Author(s): **Steve Virostek**

Date: 10/17/10

TECHNICAL NOTE

MICE Spectrometer Solenoid: Summary of Proposed Modification Plan

Figure 1: Preliminary layout of the modified cooler arrangement (5 ea 2-stage, 1 ea 1-stage)

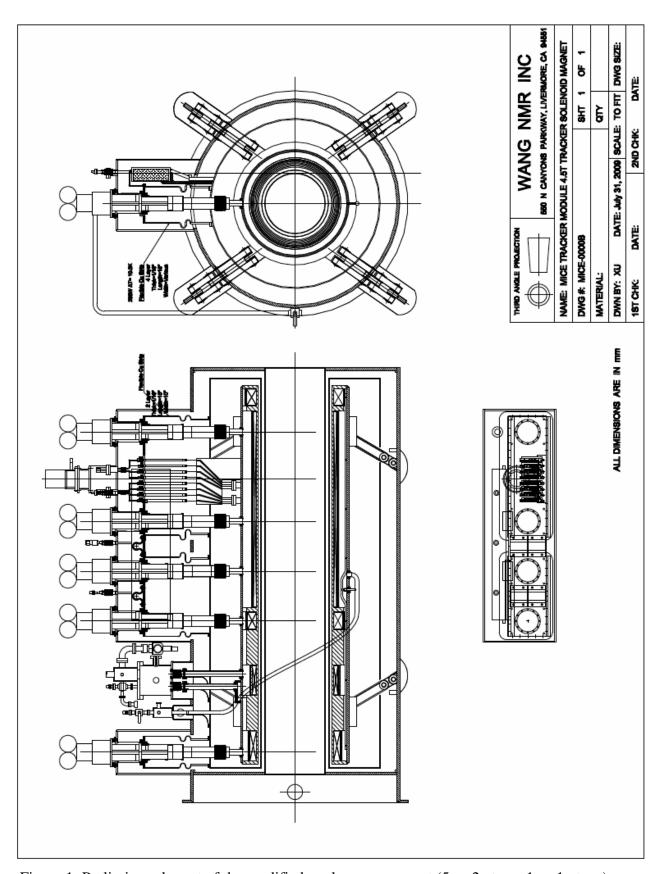
- The total cooling power will be increased by using five 2-stage pulsed tube coolers and one single-stage cooler. A layout of the proposed design showing the positions of the six cryocoolers is shown in Figure 1. This drawing represents a preliminary layout produced by Wang NMR. Note that the LN reservoir shown in the drawing will be eliminated. The detail drawings required for carrying out this approach will be generated by the vendor once the plan has been approved.
- The thermal/mechanical stabilities of the cold leads will be improved by adding extra copper/superconductor near the cold mass feedthroughs (refer to the lead failure analysis write-up for details). The added copper lead material will significantly stiffen the leads to prevent movement caused by electromagnetic forces and will provide a more effective means of cooling through conduction.
